REF: EN010147 Botley West Solar Farm Representation: Feedback to PVDP Change

PVDP Proposed Changes

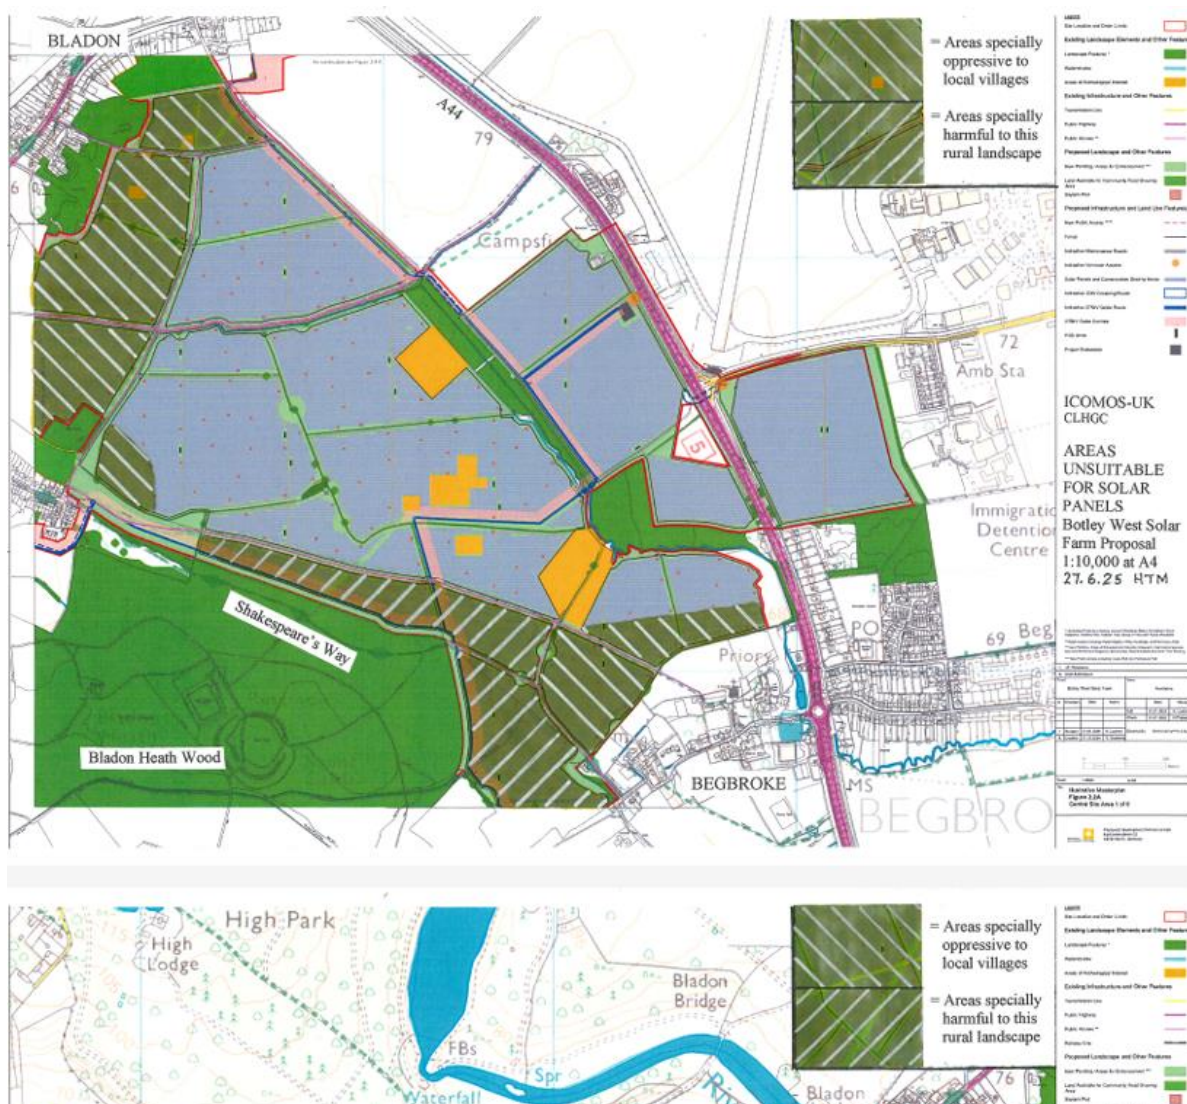
1. My observation having walked the fields with reference to the proposed changes, is that If PVDP conceded the two fields outlined with the **red outline**, then most of the concerns would be removed, and the current natural environment would be maintained. The main walks of Bladon, and visitors to Churchill's Grave, is down Orchard Field Lane and across two footpaths towards St Martin's Church, the main one being the furthest pathway which runs along the Rowel Brook, and ends up at St Martin's Church. The hedge row is mature and would act as a natural barrier to the solar panels behind. This would provide a 30 – 45 minute walk without observing any solar panels.

My concern is the concentration of walkers from their regular 30 – 60 minute walks to the narrow section of fields now proposed.
